Service Bulletin

Category S	Applicable Model/s 1995 Millenia	Subject CENTER SUNVISOR HOLDER CRACKED	Bulletin No. 015/96
			Issued 04/18/96
			Revised 05/15/96

NOTE: The PNMC for this concern has been updated. Please replace the original bulletin with this revised copy.

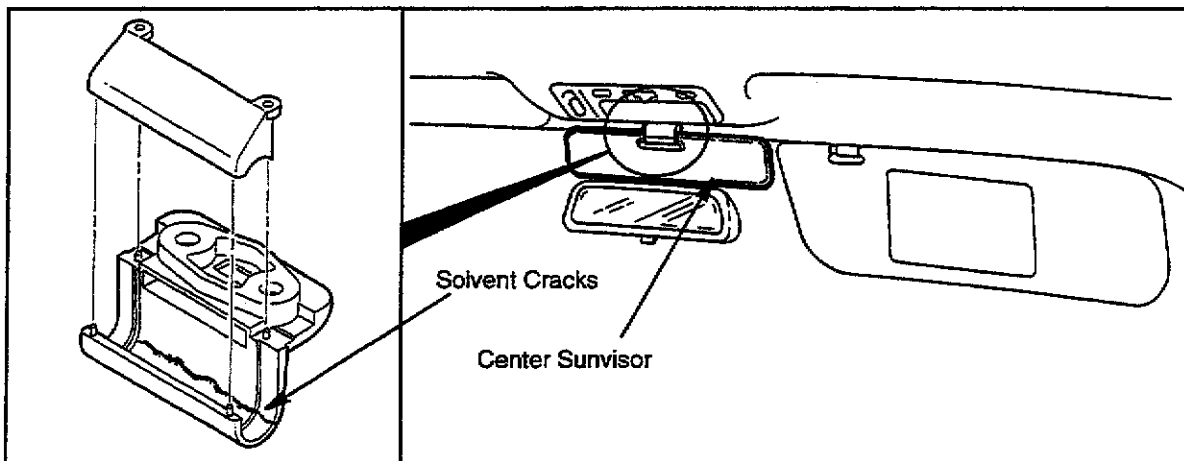
When positioning the sunvisor, the center sunvisor holder may crack.

Ultra-violet rays deteriorates the grease applied to the holder. This deterioration results in a solvent crack across the center sunvisor holder.

The grease applied to the holder has changed.

Customers complaining of this concern, should have the holder replaced.

1. Verify concern.
2. Replace the holder.
